OPTIONAL SERVICE BULLETIN NO. OSB 40NG-082 REV. 0

Installation of Alternate Electric Fuel Pump.
ATA code: 28-00

WORK INSTRUCTION WI-OSB 40NG-082 REV. 0

Figure 1. Fuel pumps overview.

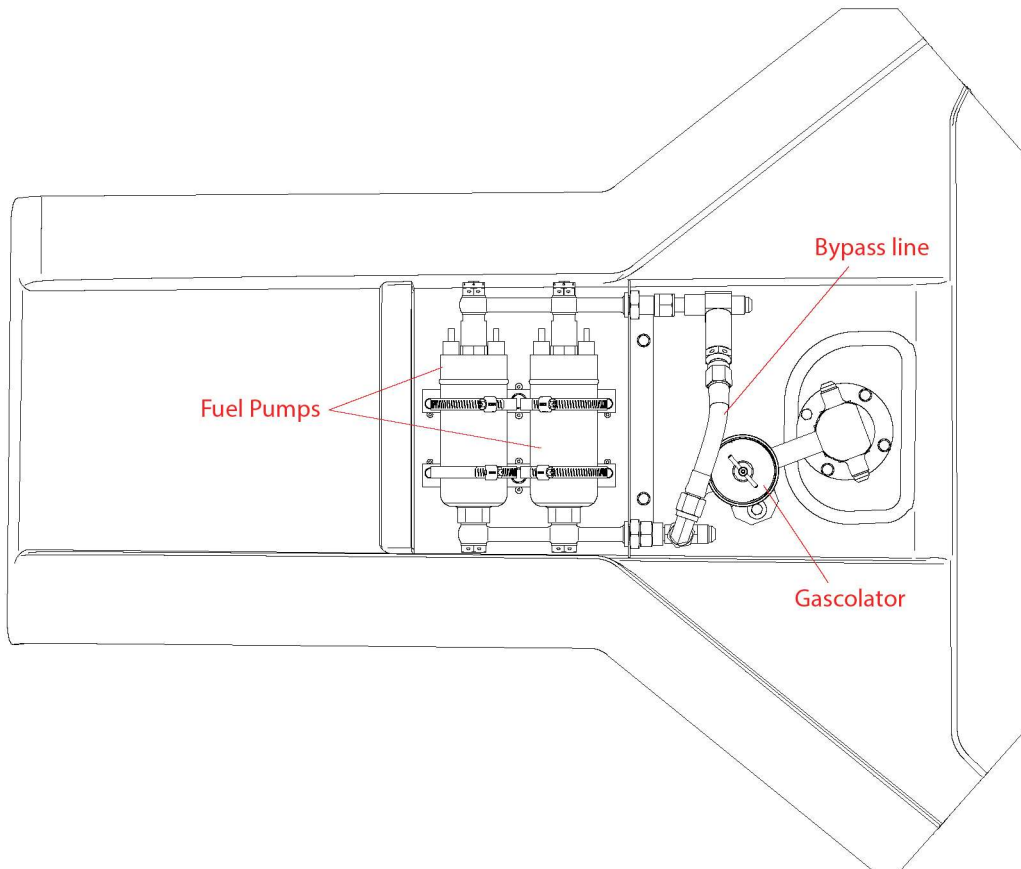
1. Incorporate AMM-TR-MÄM 40-1119 into the Airplane Maintenance Manual or use an AMM revision in which AMM-TR-MÄM 40-1119 has been incorporated.
2. Incorporate AFM-TR-MÄM 40-1119 into the Airplane Flight Manual or use an AFM revision in which AFM-TR-MÄM 40-1119 has been incorporated.
3. Remove the existing fuel pump assembly D44-2823-51-00. Refer to AMM Section 28-20.

4. Remove the existing mounting brackets with their screws and washers.

Figure 2. Mounting bracket installation. (shown inverted for clarity)

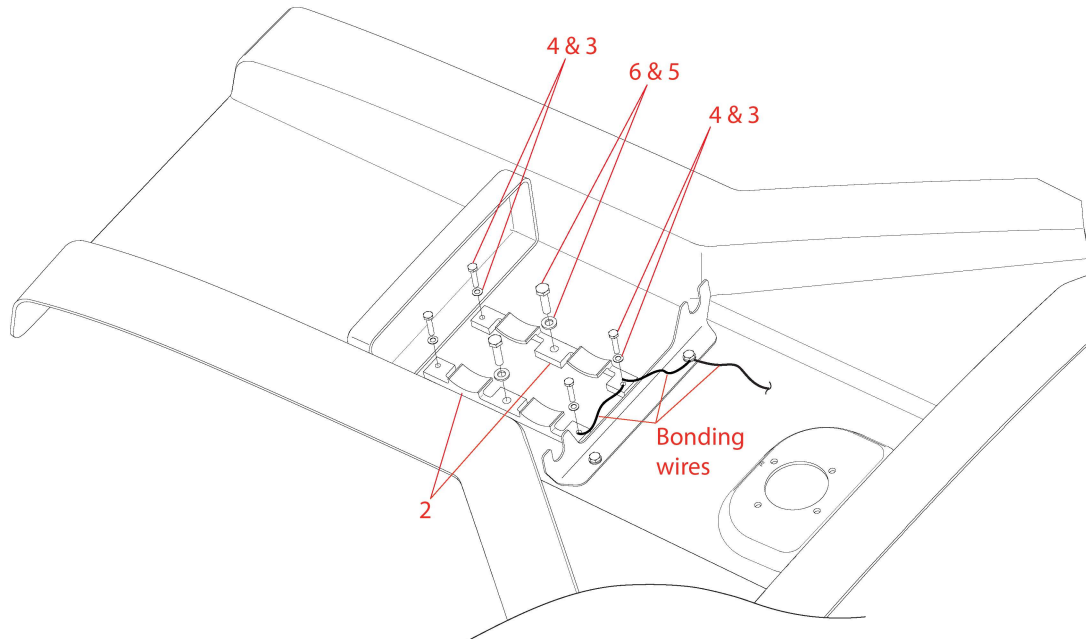
5. Install the new mounting brackets (item 2) using screws (items 4 and 6) and washers (items 3 and 5). Refer to Figure 2 for installation and orientation of the brackets (item 2).

NOTE: Reuse existing bonding wires if they are serviceable.

NOTE: Torque the worm drive clamps that hold the fuel pumps to the mounting brackets to 3 - 3.5 Nm (2.2 - 2.6 lbf.ft.).
